PLAN COMMISSION STAFF REPORT

Agenda Item: PC 25-020

Application Type: Development Plan

Summary: Applicant is requesting consideration of a Development Plan for a 10 tennis court complex at Community Park adjacent the Munster Community Pool at 8839 Calumet Avenue.

See subject frontage area to be improved with trail/sidewalk and landscape material.

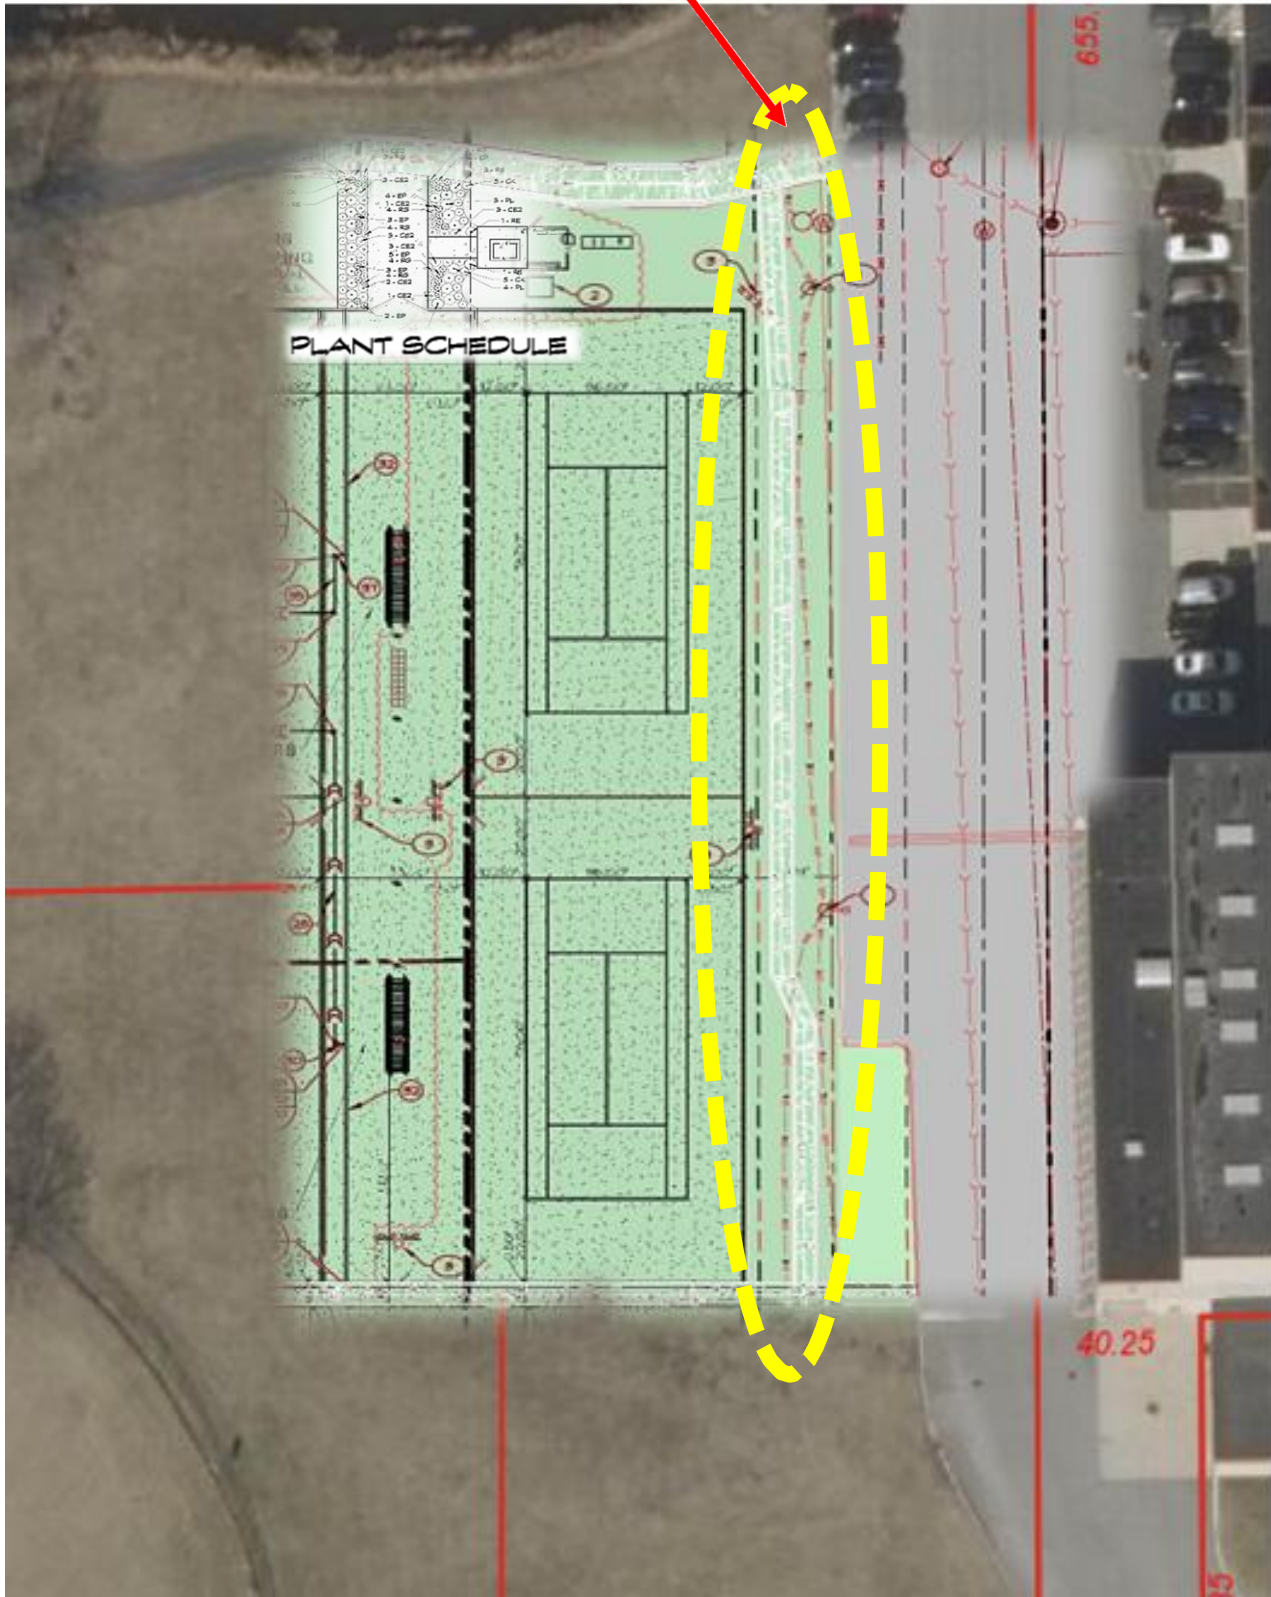
It's recommended that the proposed tennis court sports field complex continue to define the site's frontage along the east side of the project site, adjacent to existing parking area with a trail/sidewalk connecting the existing north trail entrance to the proposed south walkway entrance. It is also recommended that this frontage be defined with additional landscape materials to be maintained as defined in Section 5.01 of the the Park and School Town of Munster lease agreement.

See subject frontage area to be improved with trail/sidewalk and landscape material.

Staff recommends additional discussion regarding the east frontage of the proposed sports facility. Staff supports defining the sports field frontage along the east side of the project site, adjacent to the existing parking area, with a trail or sidewalk connecting the existing north trail entrance to the proposed south walkway entrance. Landscape materials should be maintained in accordance with Section 5.01 of the Park and School Town of Munster lease agreement.

PLANT SCHEDULE

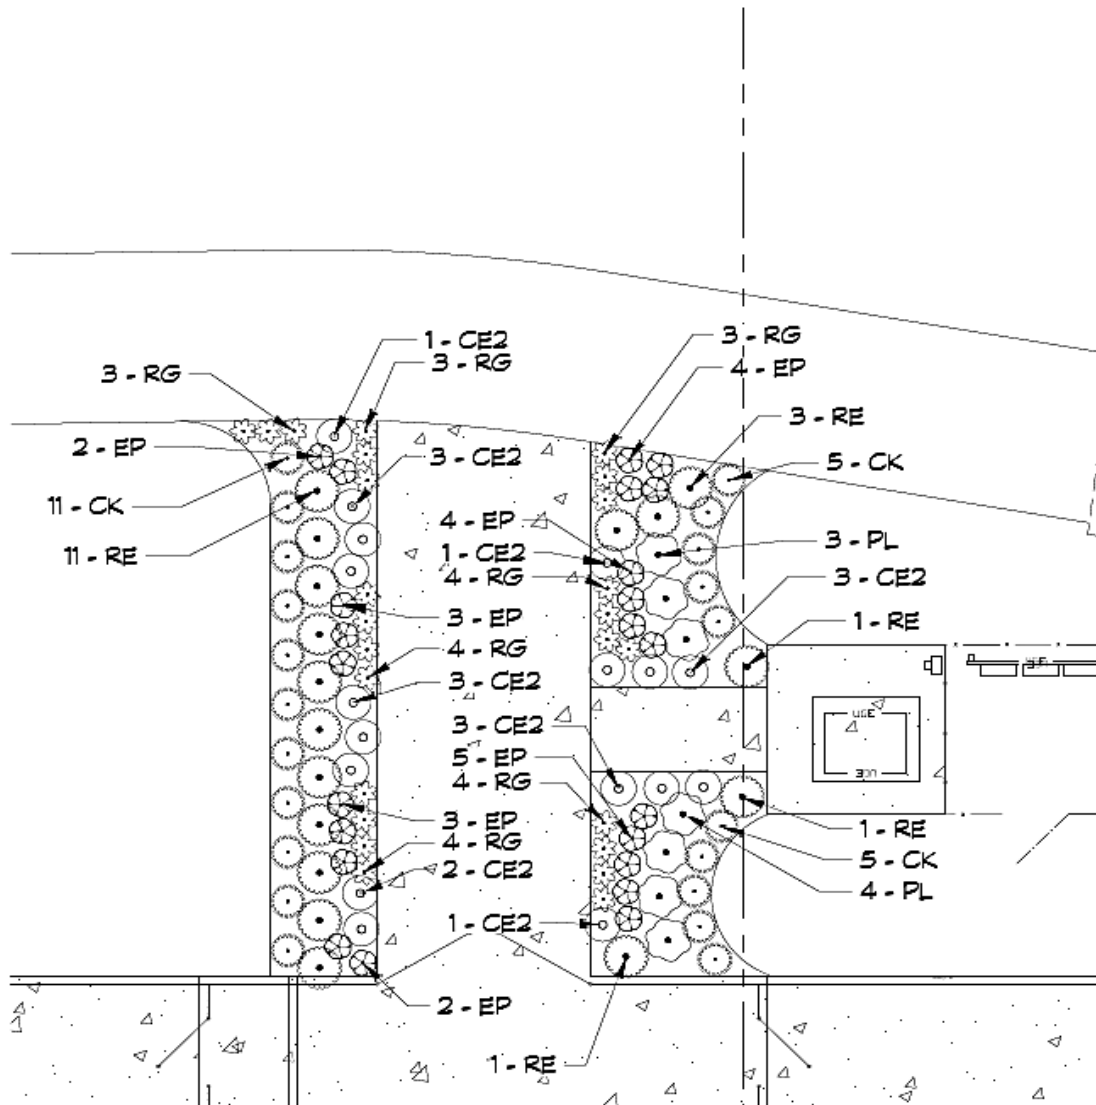
Staff finds that the Commission conducted and closed the Public Hearing for this matter on October 14, 2025. The applicant has submitted a complete application with all required supporting documents and has recently updated the civil plans to include a landscape sheet (L-1). However, the proposed landscaping is limited to the north entrance along the existing east–west trail. While the planting schedule for this area may help define the primary entrance, it does not adequately establish the frontage of the tennis court complex as referenced in the applicable code.

Finally, staff has not yet received the stormwater and drainage review report from the Town Engineer regarding the proposed underground storage and detention areas. However, staff recommends approval with the condition that the applicant comply with all engineering stormwater recommendations. Staff further recommends that, in accordance with Town Code, a sidewalk or trail connection—along with an accompanying planting schedule—be installed along the east side of the tennis courts, in proximity to the parking lot area. This connection should link the northern trail entrance to the proposed southern sidewalk entrance to establish a defined sports field frontage where no building frontage is provided
